D350-748-243TRN
Job Sheet 181742

Part Name: Crosstube Installation, High Aft

DART AEROSPACE LTD HAWKESBURY, ONTARIO, CANADA	
DRAWING NO. D350-748-243	REV. A SHEET 1 OF 4
TITLE CROSSTUBE (AS 350/355 HI AFT)	SCALE NTS

DRAWING NO. D350-748-243	TITLE CROSSTUBE	REV. A	DART AEROSPACE LTD ENGINEERING ORDER		D.E.O. NO. D350-748-243-A-1	SHEET NO. SHEET 1 OF 1	SCALE NTS
DRAWN <i>q</i>	CHECKED <i>ASS</i>	MFG. APPR. <i>[Signature]</i>	APPROVED <i>[Signature]</i>		DE APPR. <i>[Signature]</i>		
DATE 15.11.18	DATE 15.11.18	DATE 16.02.19	DATE FEB 19 2016		DATE 2016.02.19

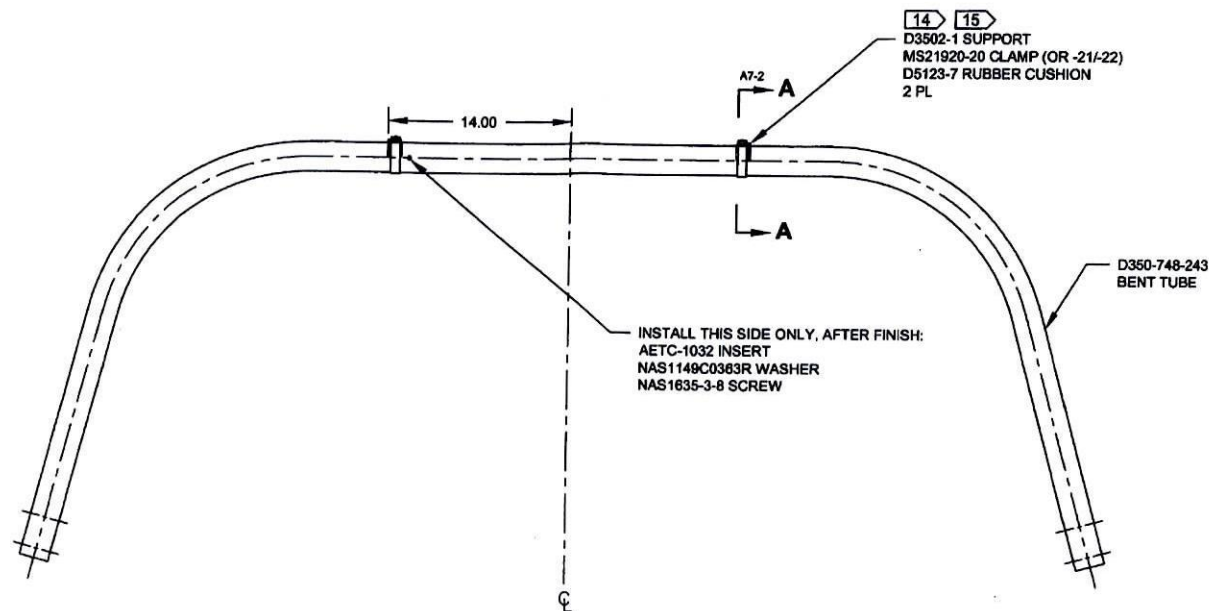
AMEND NOTE 2 (SHEET 1) AS FOLLOWS:

- 2) FINISH: PREPARE SURFACE PER DART QSI 005 4.1.4
 PRIME INSIDE AND OUTSIDE PER DART QSI 005 4.2
 PAINT OUTSIDE PER DART QSI 005 4.2
 OR
 POWDER COAT WHITE (4.3.5.2) PER DART QSI 005 4.3
